Addendum 03

PROJECT: Fairfield Elementary School Office and Support Area Improvements
2825 Fairfield Avenue
Fort Wayne, Indiana 46807

PROJECT #: 25066.02

3 GROUND FLOOR PHASING PLAN
G1.2 1" = 20'-0"

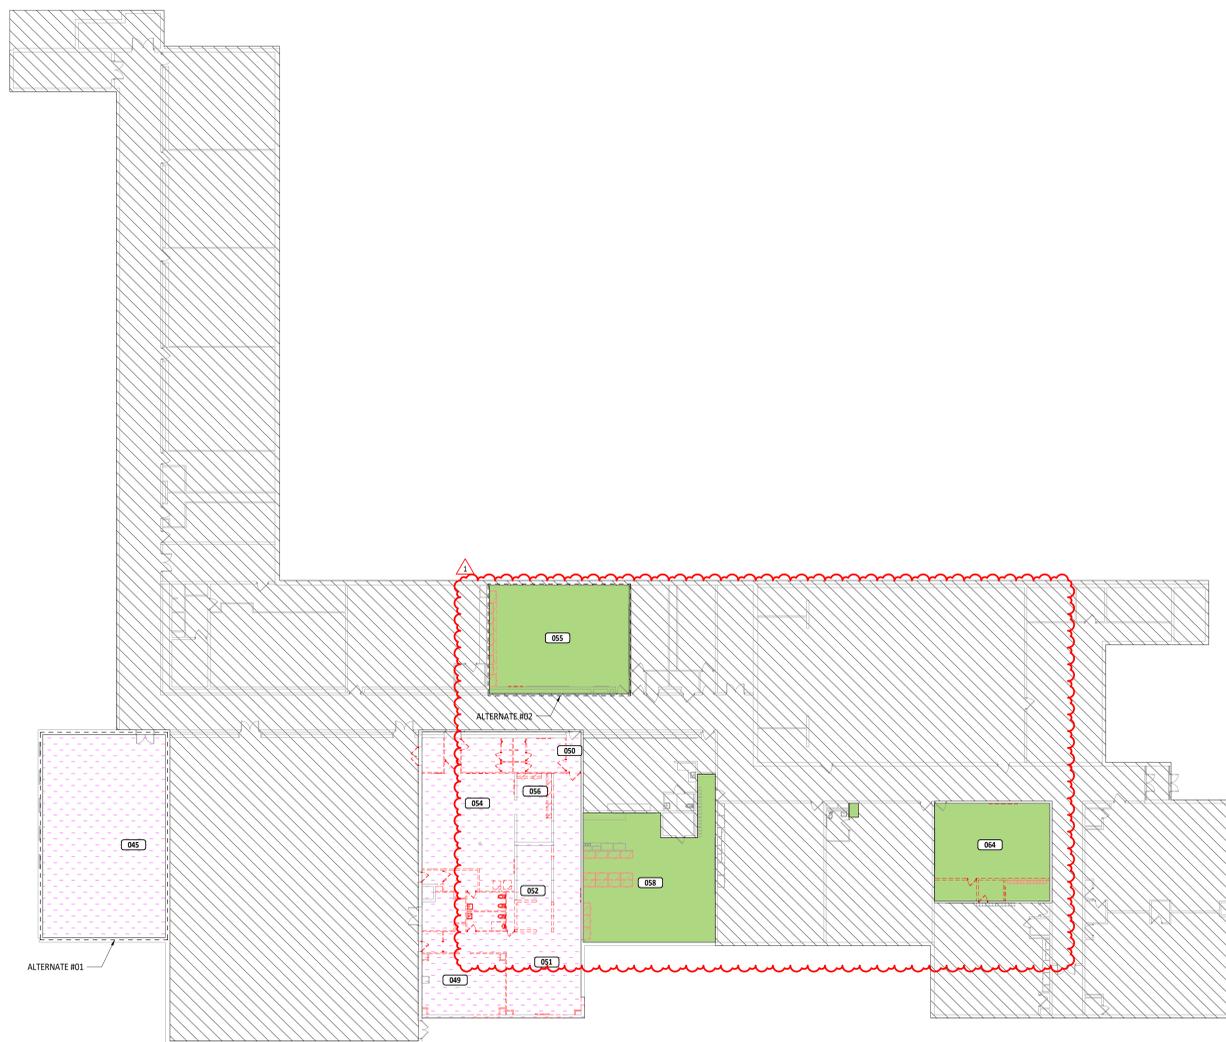
1. DRAWING SHEET G1.2 PHASING PLANS
 - a. REVISE rooms 055, 058, 064 and 150 to be Phase 2b.

1
A2.0a
GROUND LEVEL FLOOR PLAN
1/8" = 1'-0"

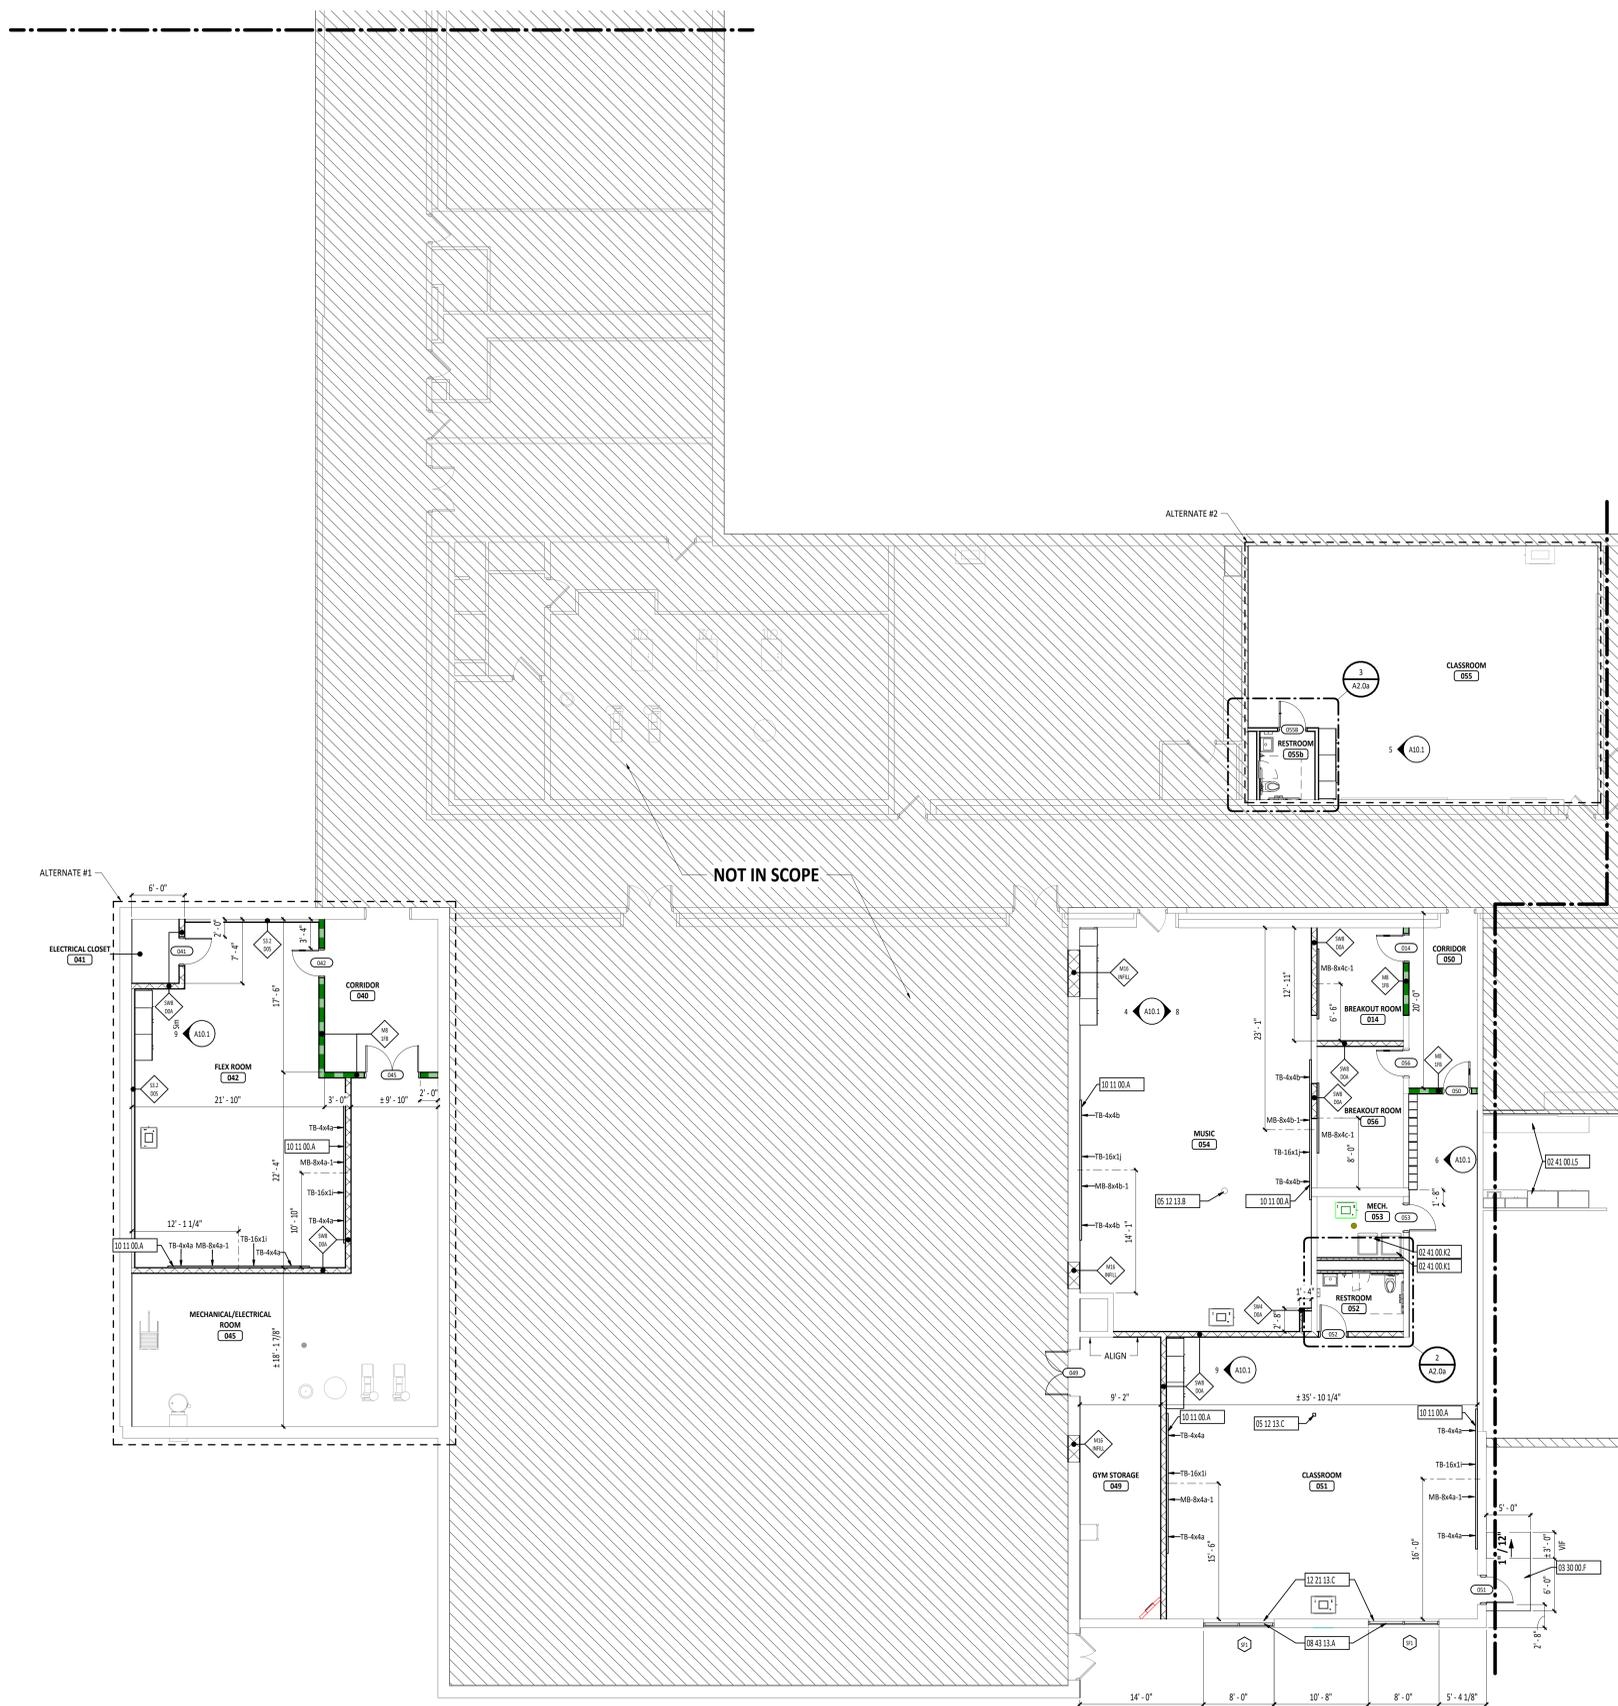
2. DRAWING SHEET A2.0a Ground Level Floor Plan – Unit A
 - a. REVISE wall dimension on drawing 2/A2.0a.

SHEET NUMBER:
P2.1

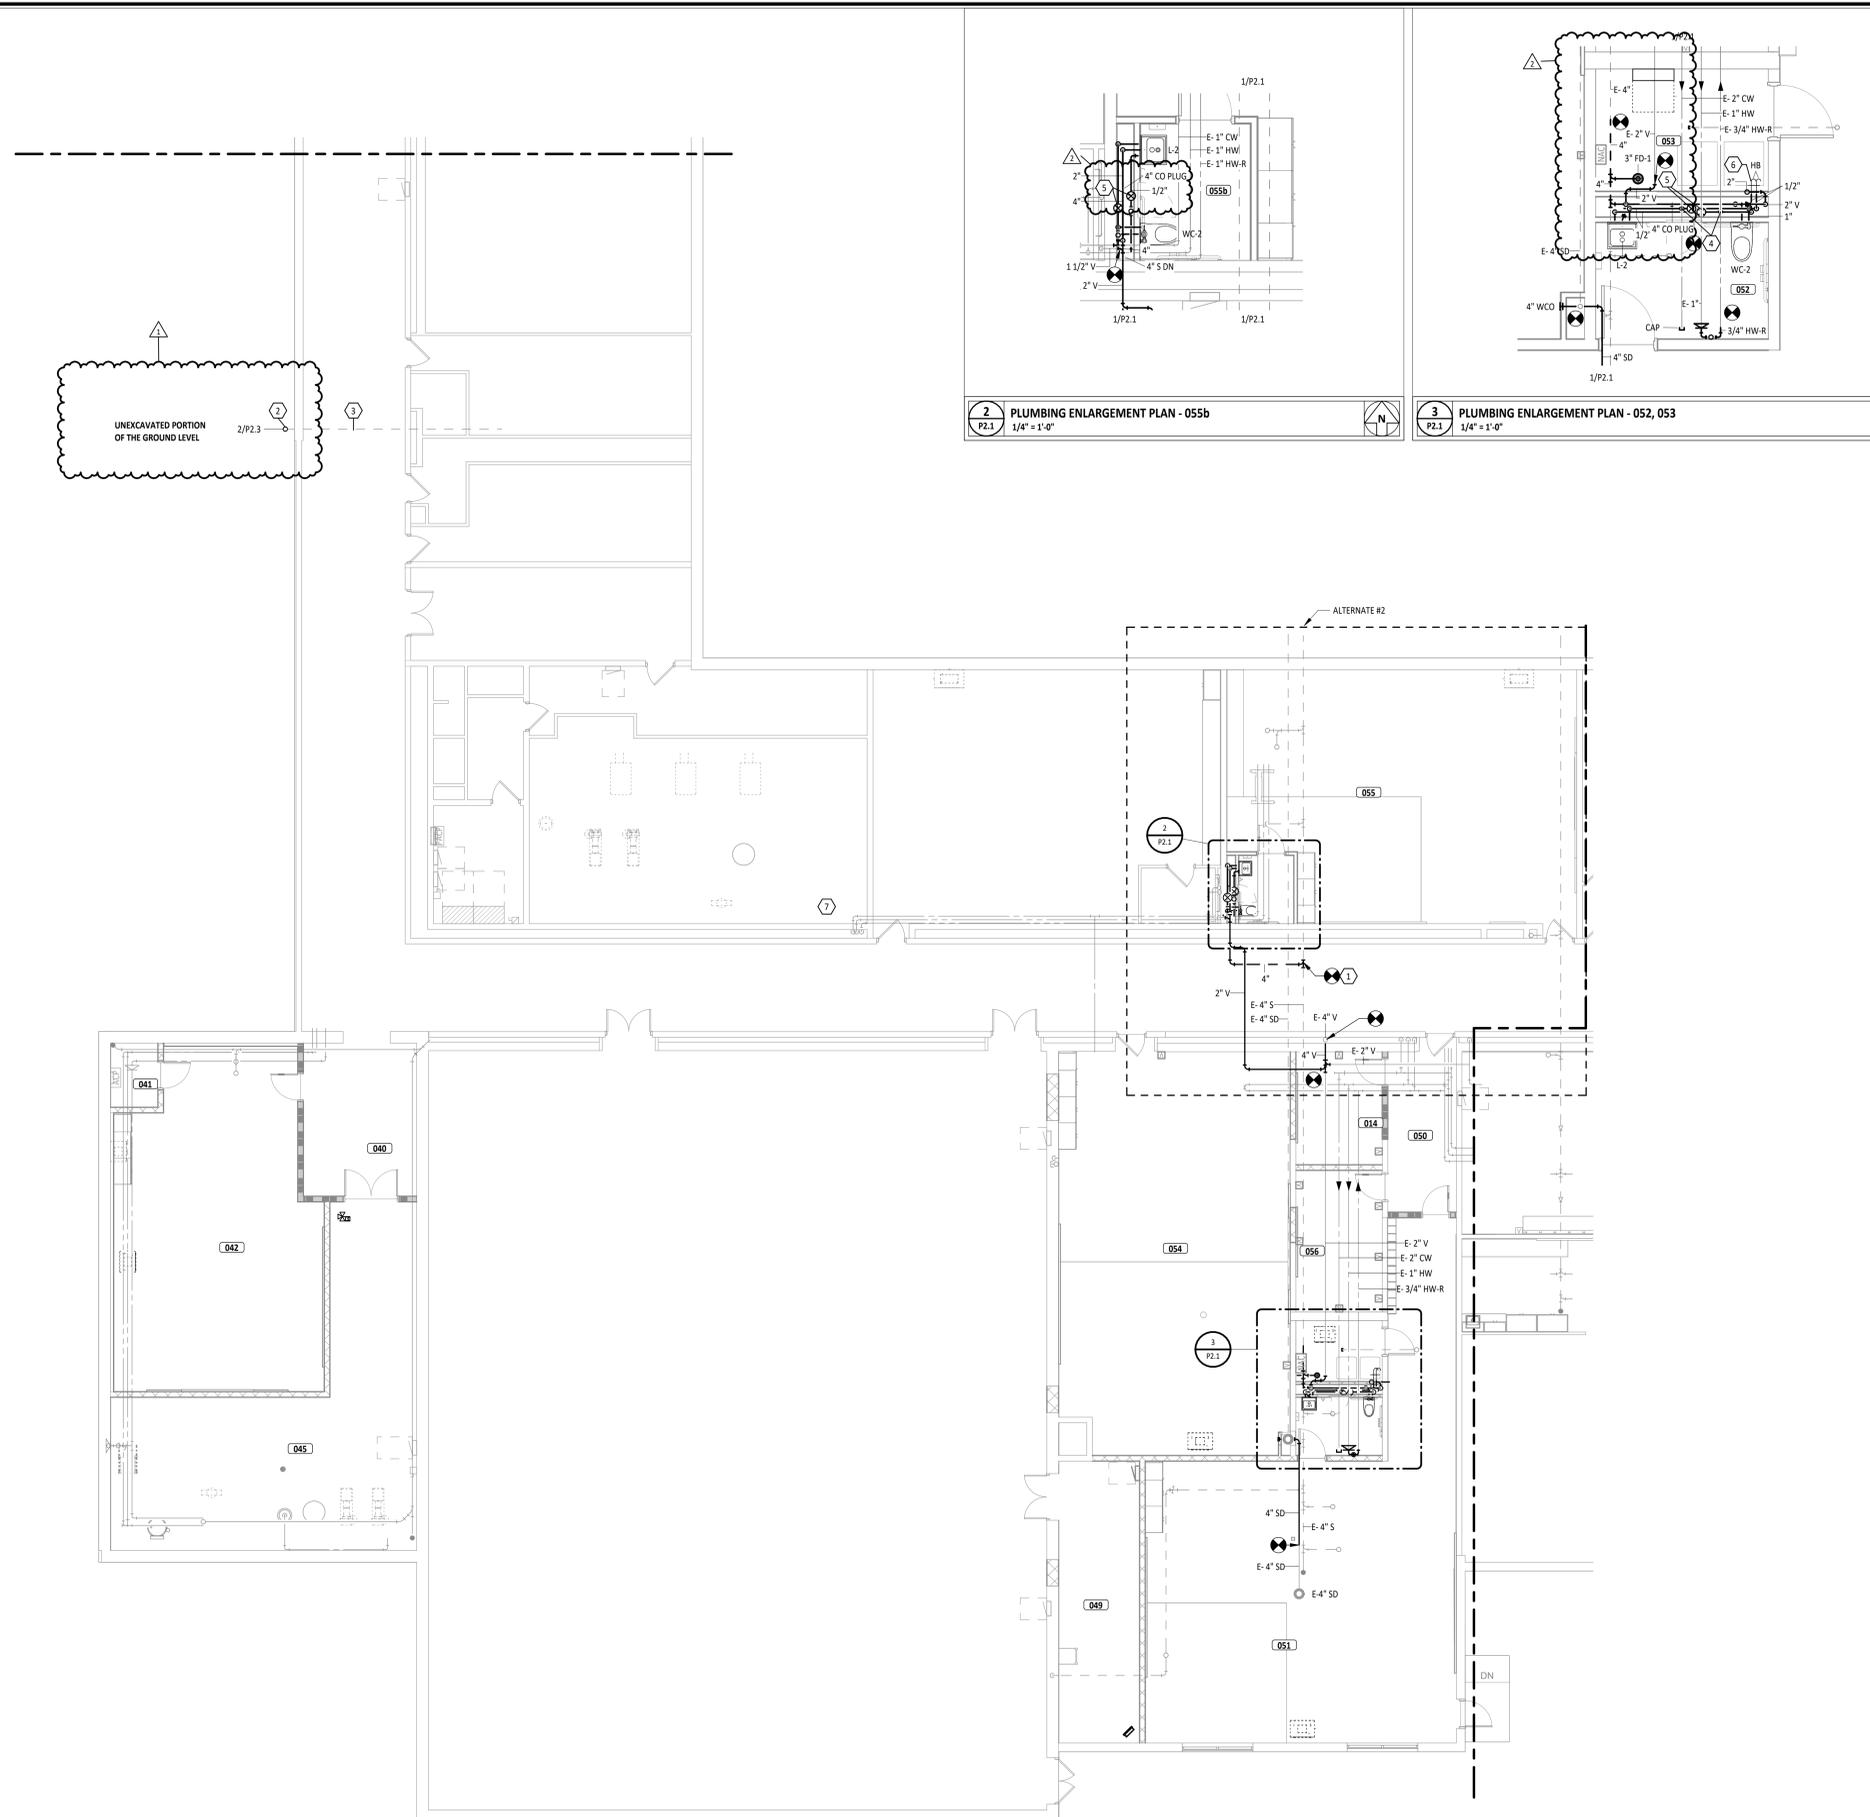
3. DRAWING SHEET P2.1 Ground Floor Plumbing Plan – Unit A
 - a. REVISE sanitary clean outs located inside the restroom chases 055b and 052 to be clean out plugs. A typical clean out is not required for this instance. Clean out plugs to be installed above the flood rim.
 - b. REVISE floor drain location and reduce size to 3" in 053.

SHEET NUMBER:
P2.2

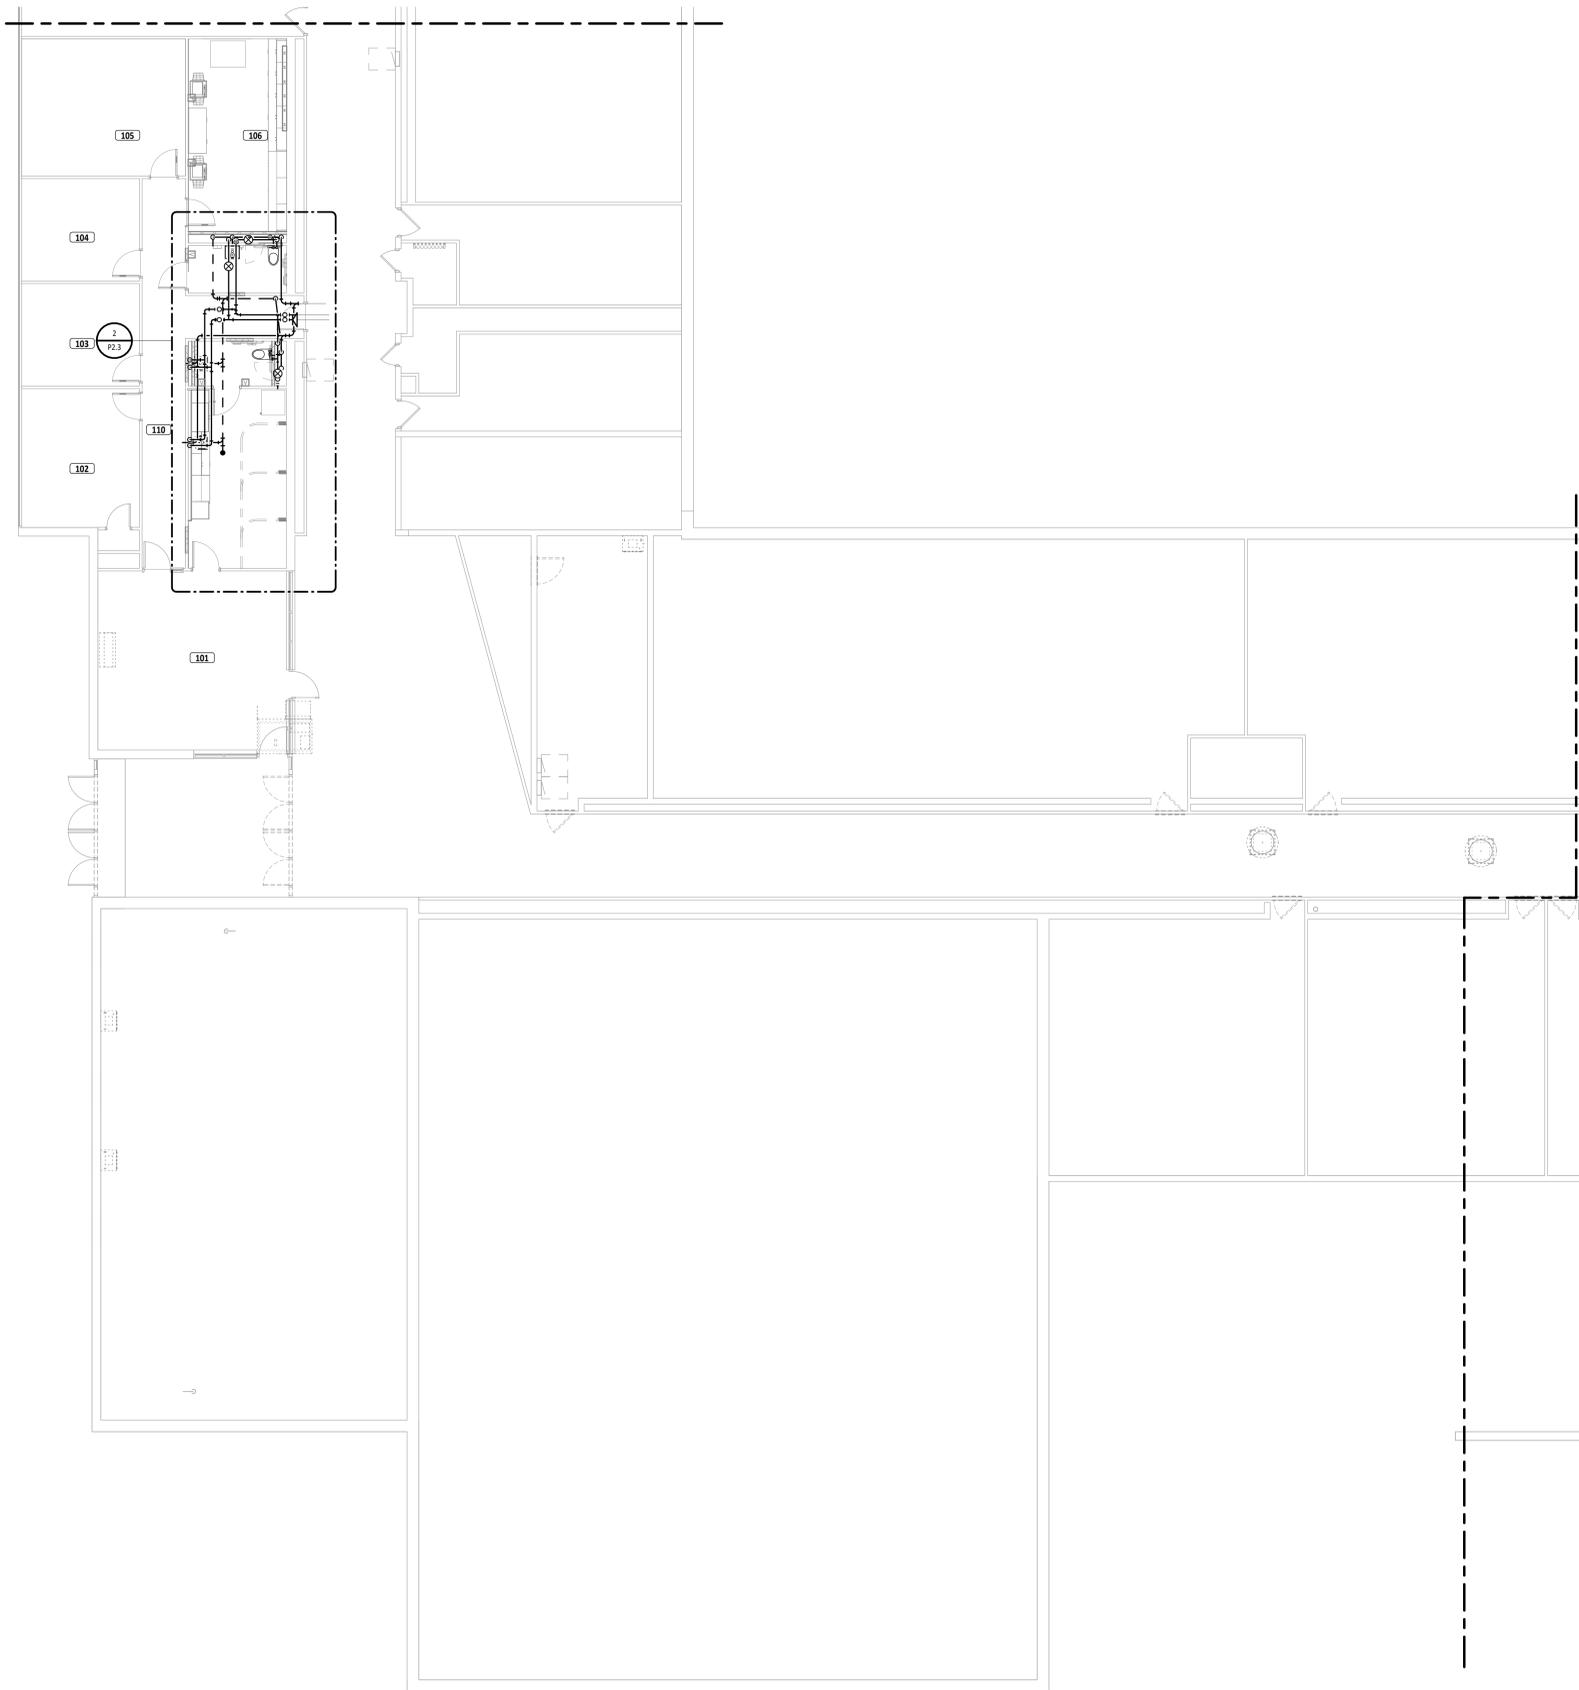
4. DRAWING SHEET P2.2 Ground Floor Plumbing Plan – Unit B
 - a. REVISE existing plumbing piping and tags near room 060.
 - b. Add keynote #3 for clarification.

2
P2.3
FIRST FLOOR PLUMBING ENLARGEMENT
1/4" = 1'-0"

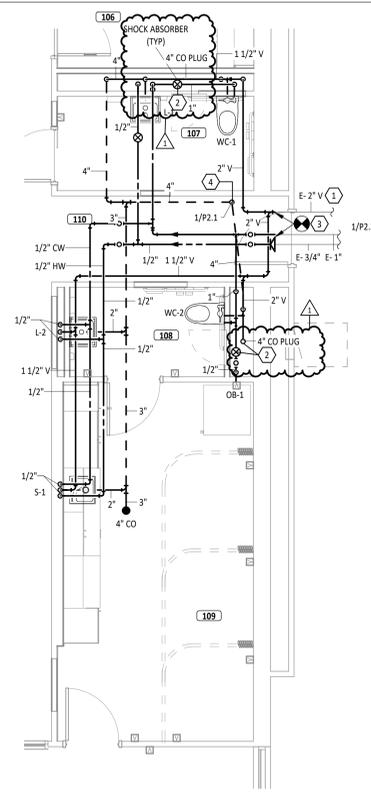
5. DRAWING SHEET P2.3 First Floor Plumbing Plan – Unit A
 - a. REVISE sanitary clean outs located inside the restroom chases 107 and 108 to be clean out plugs. Typical clean out is not required for this instance. Clean out plugs to be installed above the flood rim.
